**ADDENDUM NUMBER THREE**

**RESPONSE TO BIDDER'S REQUEST FOR INFORMATION  
BROWNFIELD CLEANUP AT THE FORMER GLOVER TRACT – RIVERWALK TRAIL  
FOR THE CITY OF CHATTANOOGA, TENNESSEE  
Contract Number D-17-008-201**

a. Drawing C501: Added “Detail – Trail Stabilization”

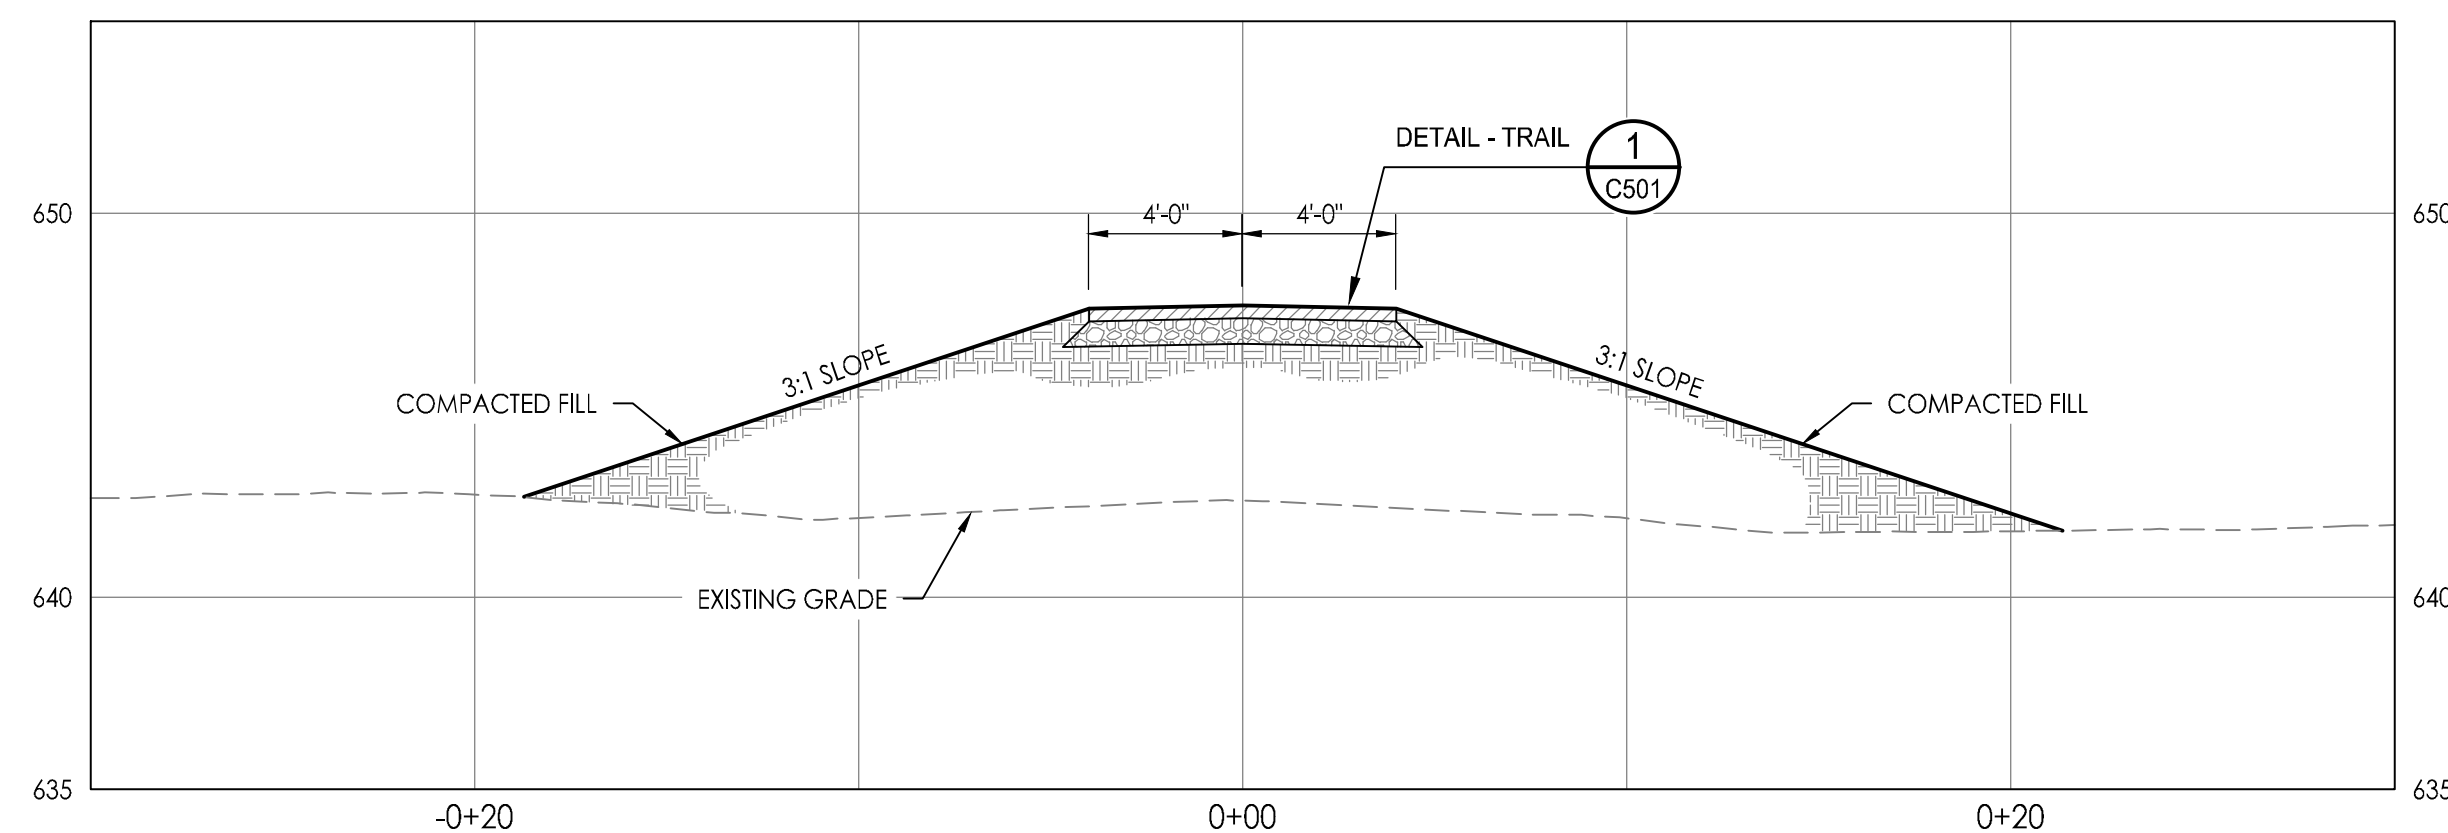
*How are stations 4+00-8+00 being dealt with? While making a site visit we noticed the area had a soft sub-grade and is low, which poses a stability issue. The sewer manhole appears to be an overflow and has been discharging raw sewage for a substantial amount of time. How is the contractor to address this?*

If soft or unstable soils are encountered during construction, no undercutting or excavation shall take place. Geotextile Type IV and TDOT Class B riprap will be placed at the direction of the Engineer. See Addendum #3.

**1** DETAIL - ROLLER COMPACTED CONCRETE TRAIL  
1/2"=1'

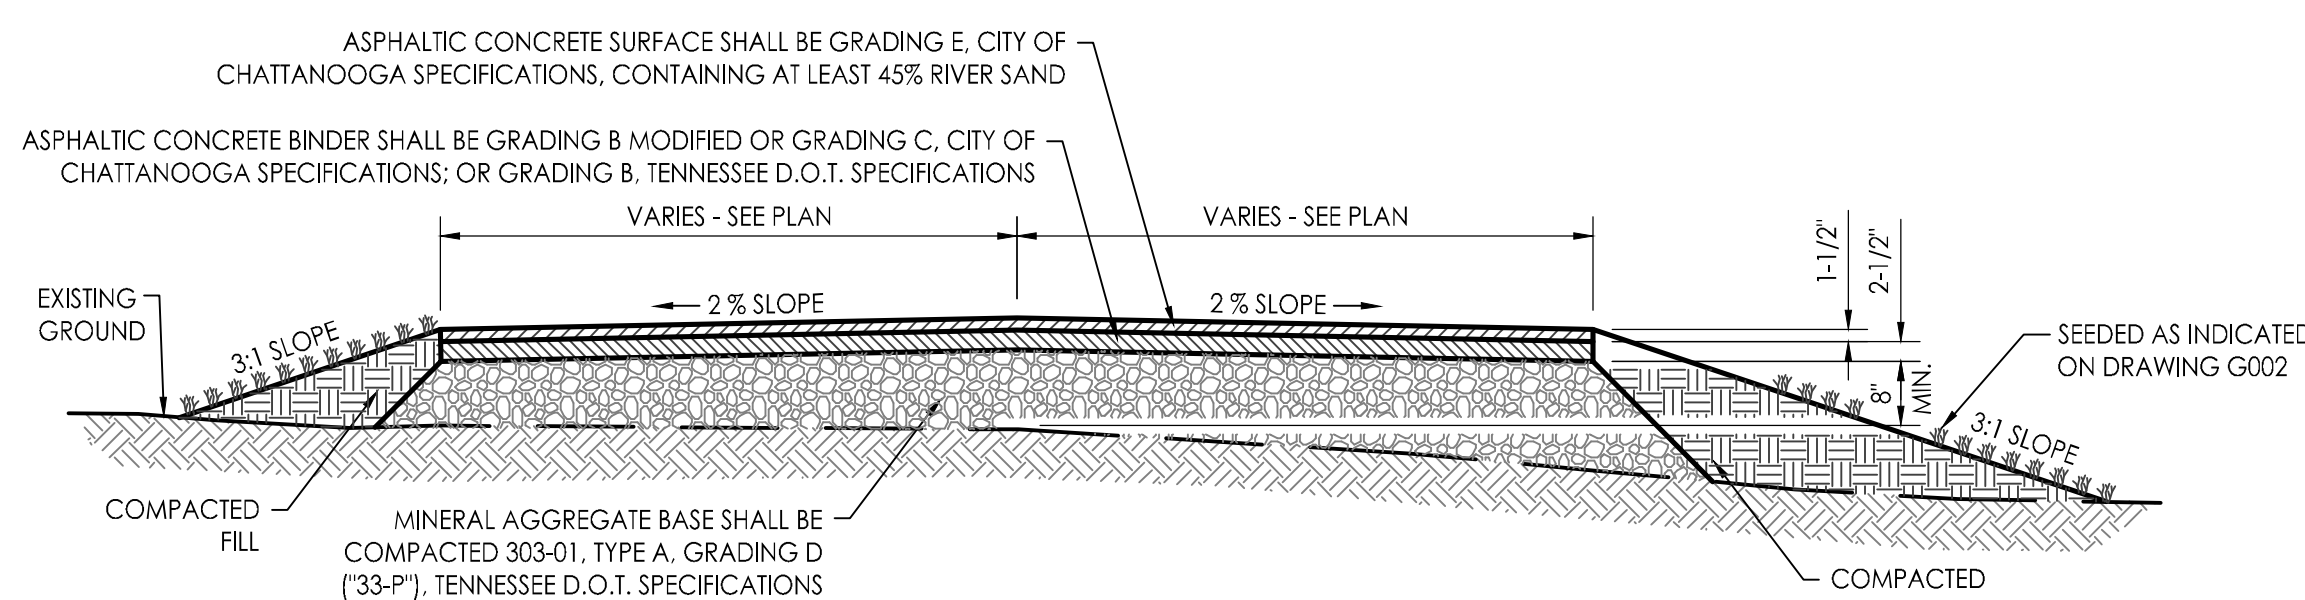
*Roller compacted concrete (RCC) minimum paving width is 11'. Will the trail be acceptable 11' width through its entirety if RCC is the best option?*

Stations 2+00 through 4+00 must be 8 feet in width to minimize the impact to the wetland. An alternate method to place concrete on this section of trail, such as a narrow width paver, shall be used. Other methods may be used if approved by the Engineer.
